MYSTERY COVE WATERPARK

DRC OVERVIEW - 2024 CURRENT PLAN

8 May 2024

SITE + PARKING PLAN

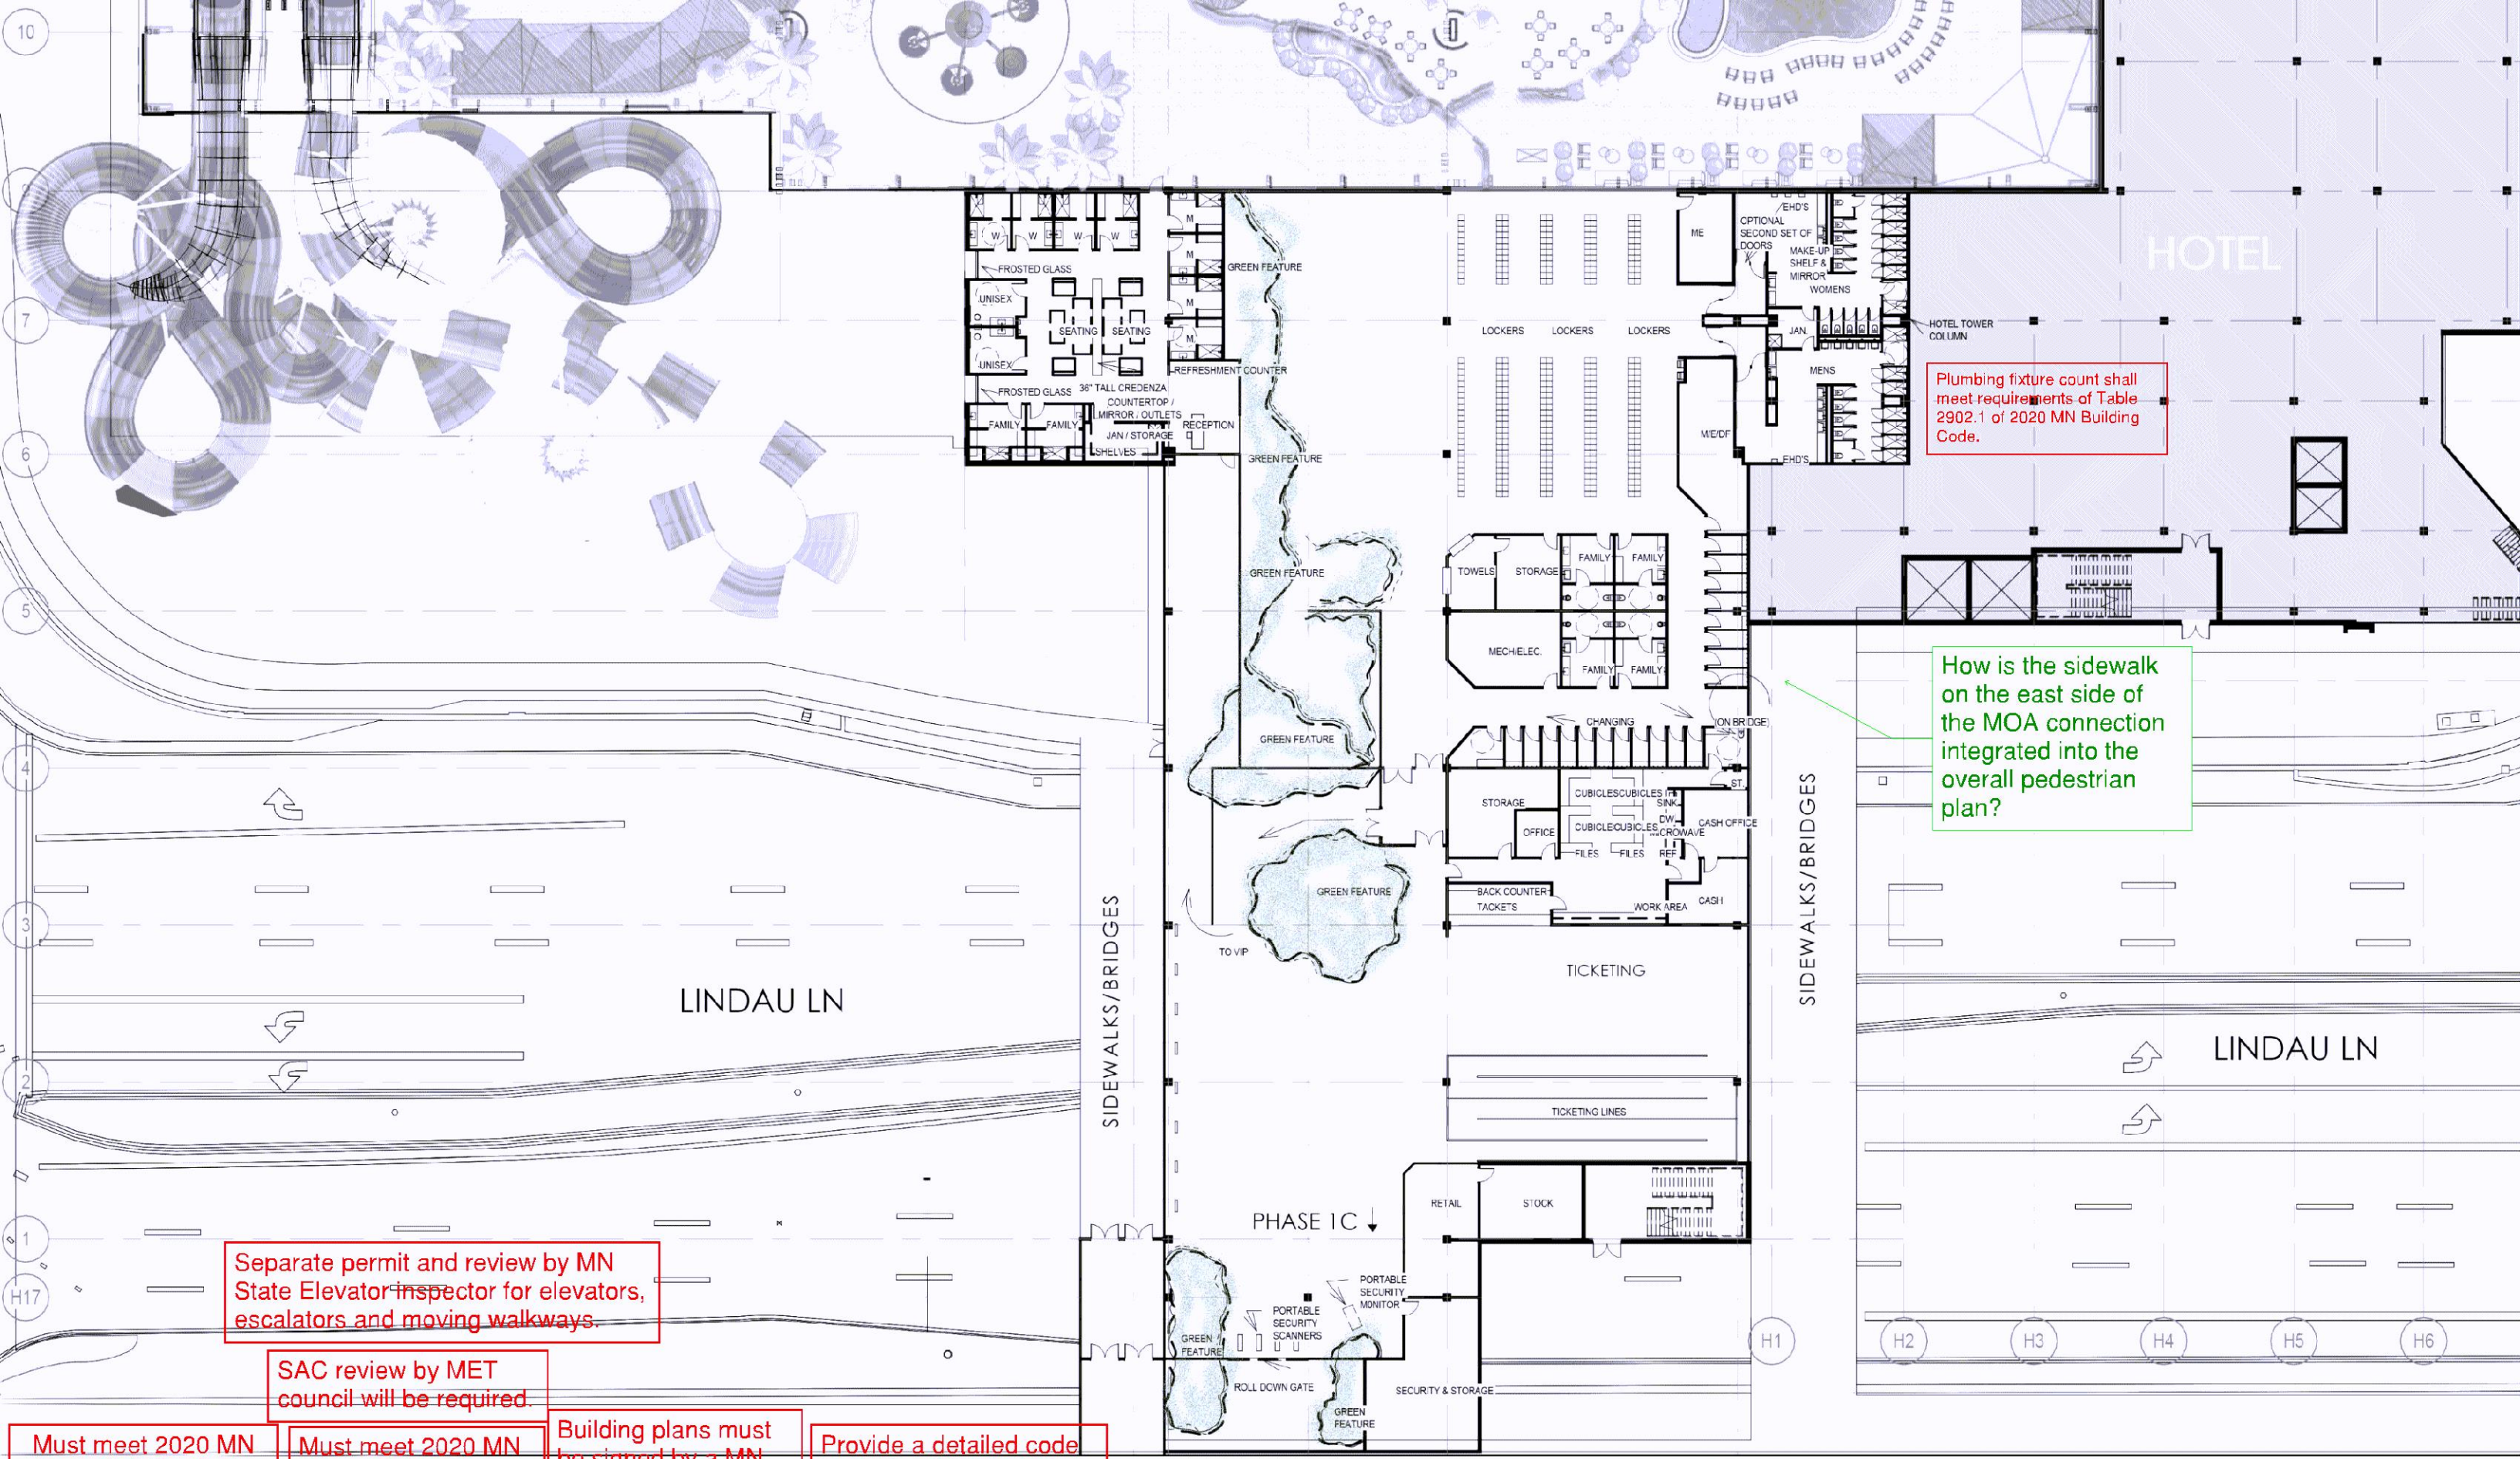
Access shall be provided to/from all stairwells on all floors and parking levels.

Maintain emergency vehicle access and circulation throughout the property for existing MOA structures.

Hose valves shall be provided throughout the lower level of the parking garage within 130' of all areas of the garage if dry standpipe or within 200 feet if installing a wet standpipe

Hydrant coverage shall be provided within 50' of the FDC and within 150' of all portions of the structure.

Fire alarm and annunciator panels and Knox box locations to be determined by the Fire Prevention Division. This project will require multiple panels and Knox boxes.

Ensure landscaping doesn't interfere with access to the building, hydrants and/or FDC.

All exterior doors that allow access to the interior of the building(s) shall be numbered in a sequential order starting with the main entrance (public entrance) as number 1 and continue in a clockwise manner.

Will the new configuration fit the existing lots or is re-platting needed?

Provide an Environmental Health Plan Review application with plan submittal for each proposed food facility.

Provide specification sheets during plan submittal on all new and used equipment being proposed for use in this facility.

Is the ring road configuration consistent with the previous plan? How does the redesign correlate to the existing parcel boundaries?

Emergency responder radio coverage meeting the requirements of appendix P in the 2020 MSFC shall be provided throughout the property and within the structures.

Type I hood exhaust with kitchen suppression system connected to the building sprinkler system required for operations creating grease laden vapors.

Additional automatic standpipes/hosevalves may be required due to limited access truck access.

Exterior access for specially rescue equipment to be provided for the waterpark.

Parking structure may be required to be sprinklered if considered enclosed per the building code.

Is future development anticipated on the corner of Lindau and 24th Avenue? How will stormwater infrastructure impact the viability of future development.

LEVEL ONE FOH: SCALE 1' = 1/32"

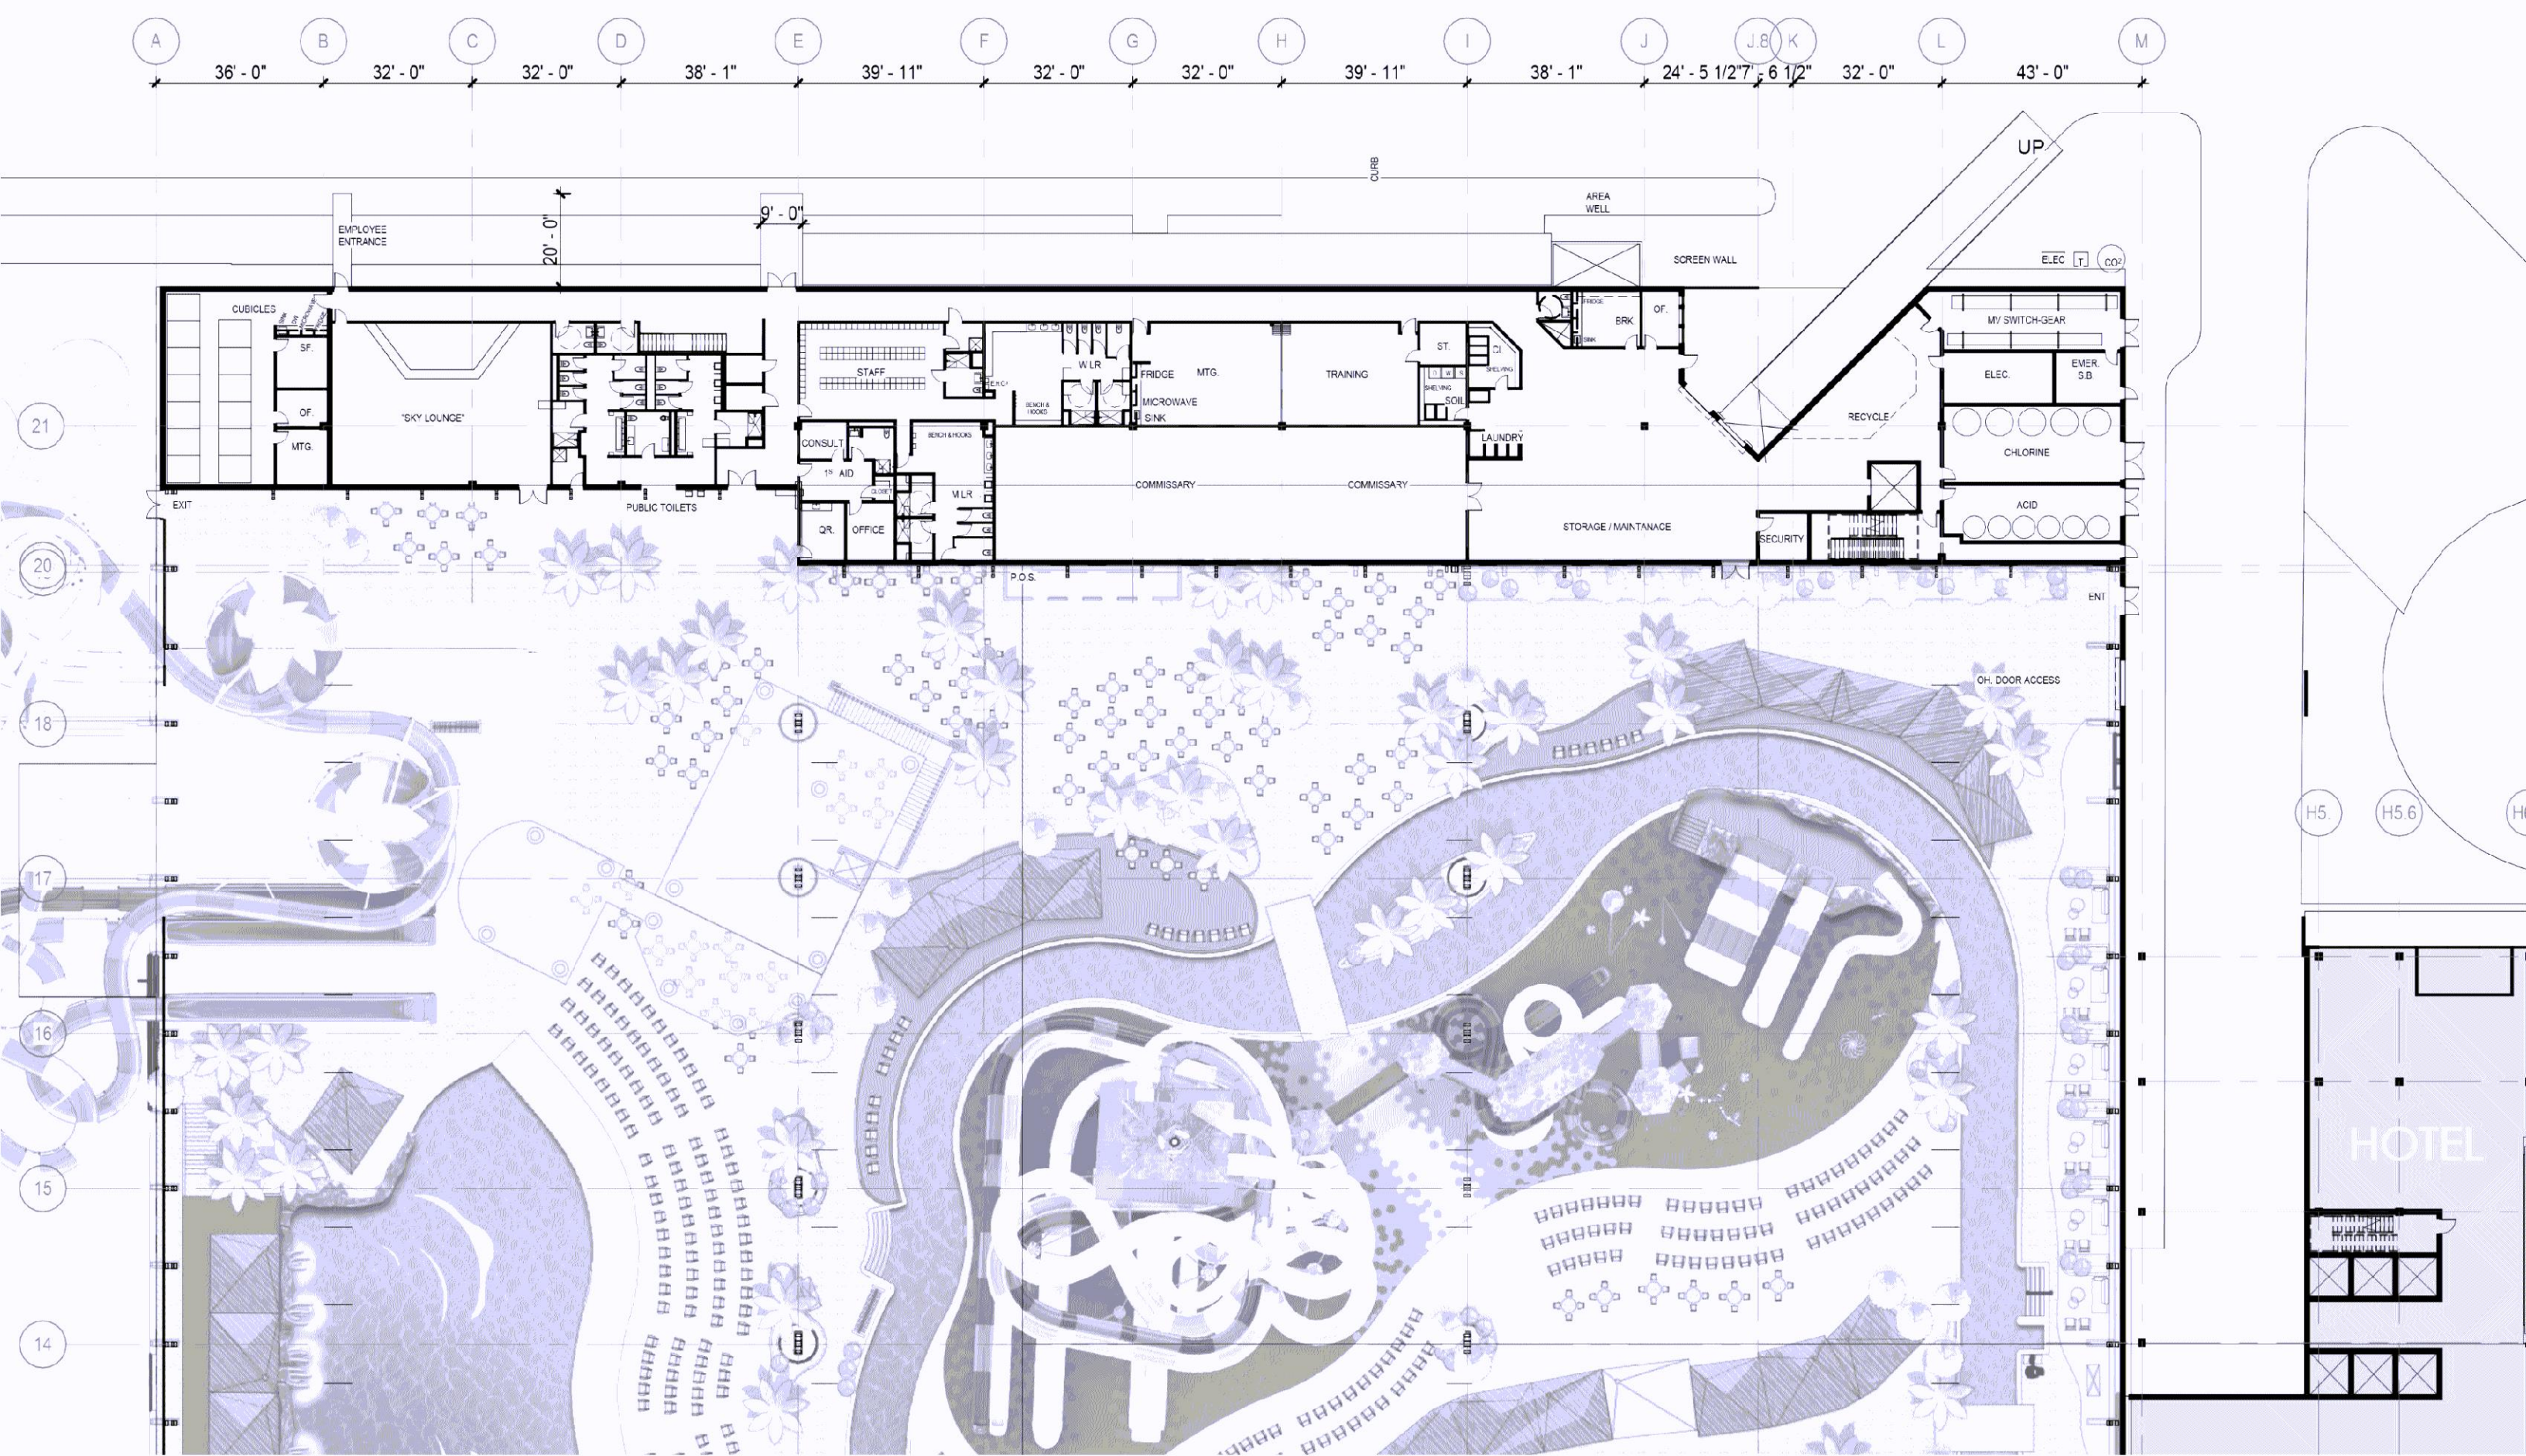
A looped water supply feeding a single, combined water service is standard requirement for all stairwells and hose valves. Standpipes for the domestic and fire service water demand.

Plumbing fixture count shall meet requirements of Table 2902.1 of 2020 MN Building Code.

How is the sidewalk on the east side of the MOA connection integrated into the overall pedestrian plan?

Separate permit and review by MN State Elevator Inspector for elevators, escalators and moving walkways.

SAC review by MET council will be required.

Must meet 2020 MN State Building Code

Must meet 2020 MN Accessibility Code.

Building plans must be signed by a MN licensed architect.

Provide a detailed code analysis with the plans.

SECTIONS A & B

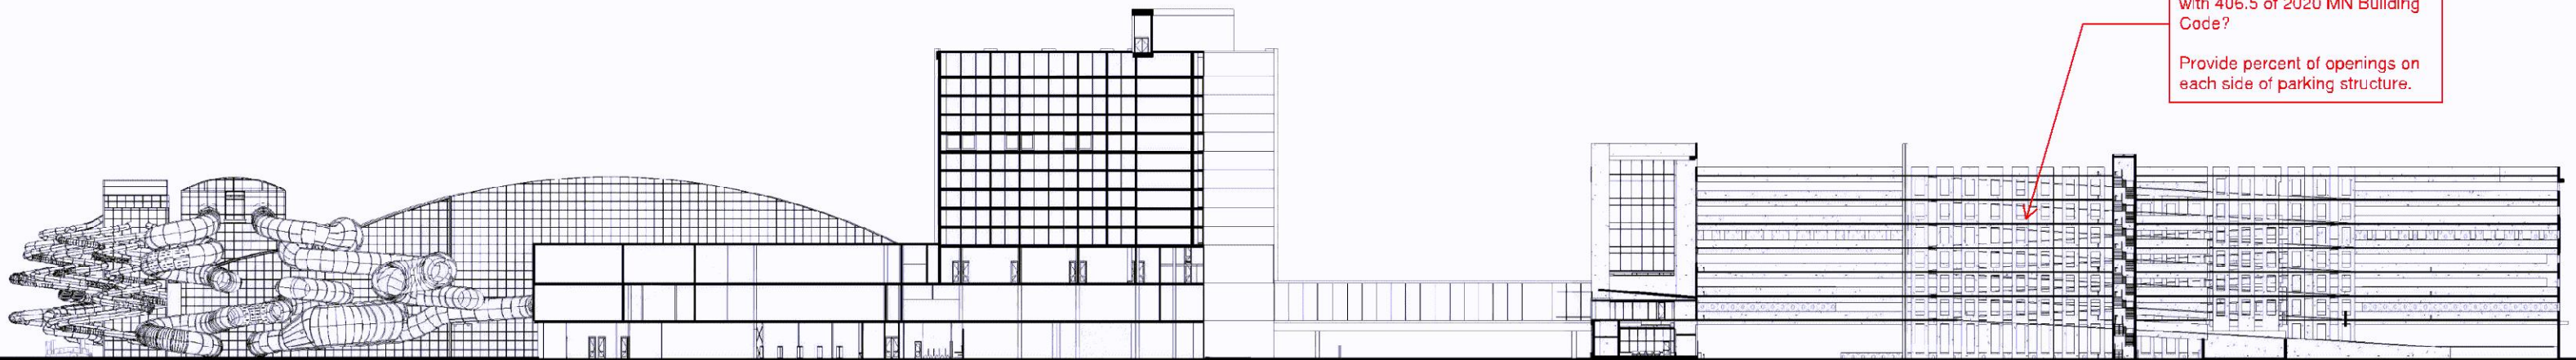
Is the parking ramp an open parking garage - in compliance with 406.5 of 2020 MN Building Code?
Provide percent of openings on each side of parking structure.
